January 14, 1981

Re: Hydraulic Gradient
River Road Interceptor Sewer

SECTION

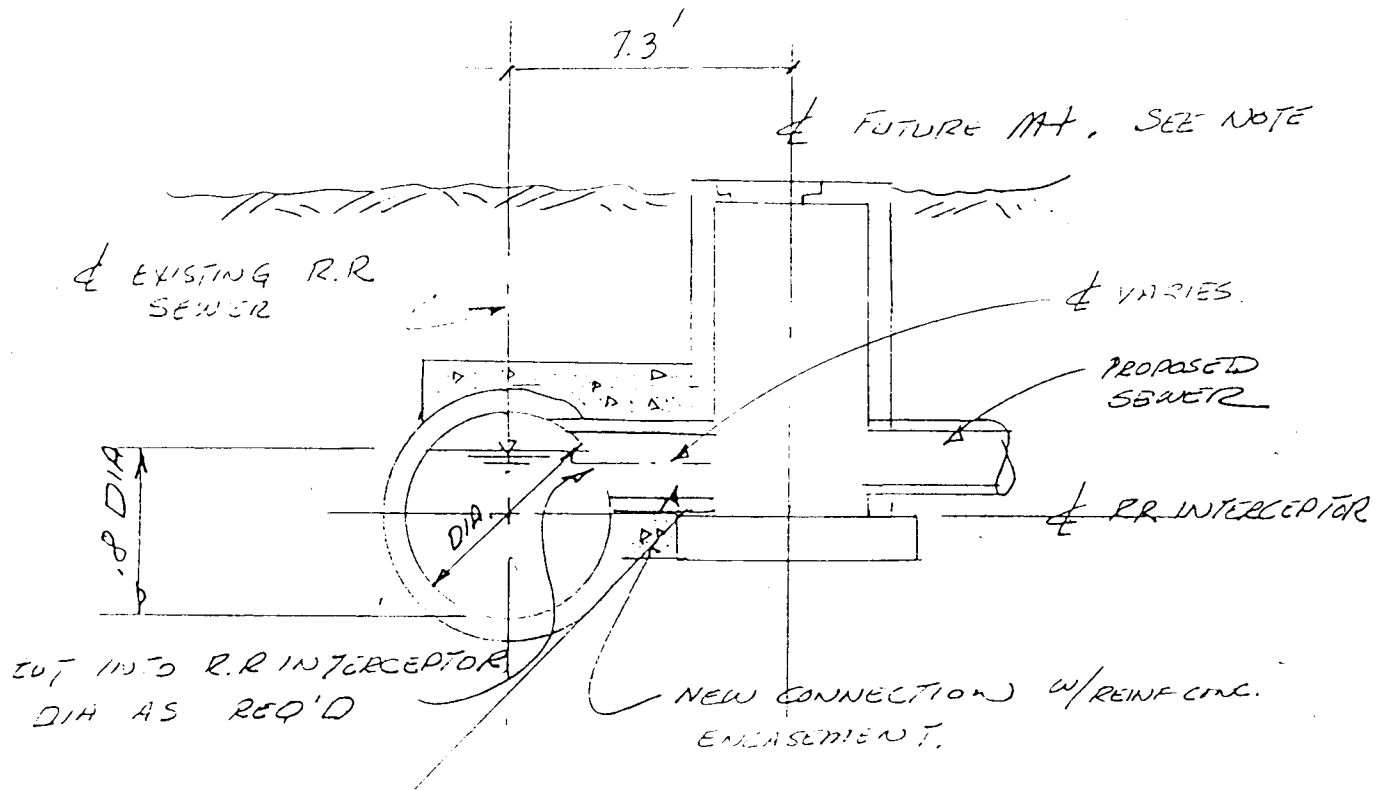
Enclosed is a drawing showing the hydraulic gradient for the sewer. We feel you should not allow any connections between the plant diversion box and manhole No. 8 as there could be times when this stretch of the sewer would be under pressure. I want to point out that this area was not envisioned to be in the service area based on the 201 Facility Plan for the project.

Then from manhole No. 8 upstream, connections could be permitted at any manhole, however it would probably be best to keep these connections to a minimum. The inverts of connections should be above the 0.8 point of the interceptor sewer.

NOTE: FUTURE M.T. SHALL BE CONSTRUCTED WITHIN 7' OF RR INTERCEPTOR M.T. UP STREAM OR DOWNSTREAM OF EXISTING M.T.
